Re: 25-26-21MO - Del Sol Turf Installation – Addendum #3

TO ALL BIDDERS:

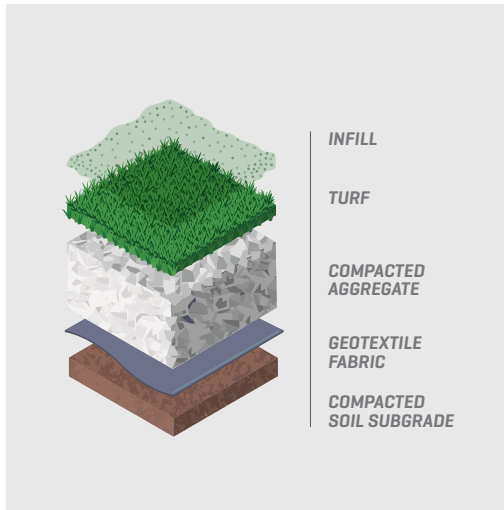
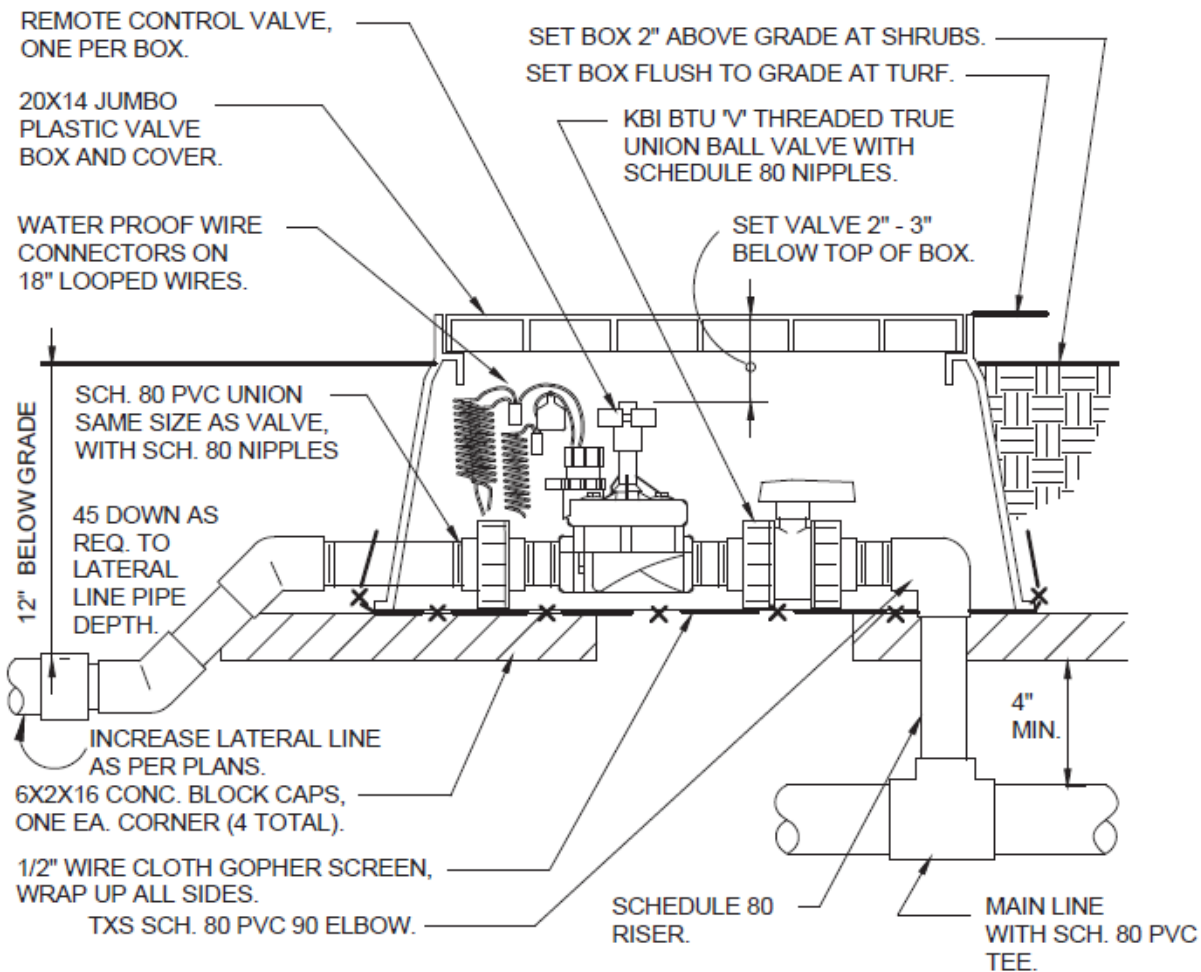
- ITEM #13 **Question:** Please recommend the manufacturers for artificial turf that has the product required on scope of work item 3.1 & has minimum 8-year manufacturer warranty on artificial turf as required on scope of work item 7.2.

- Answer:** PRO-Trade PT-TURF-50-1.
- ITEM #14 **Question:** Please provide the material for 4-inch storm drain piping as specified in scope of work item 5.
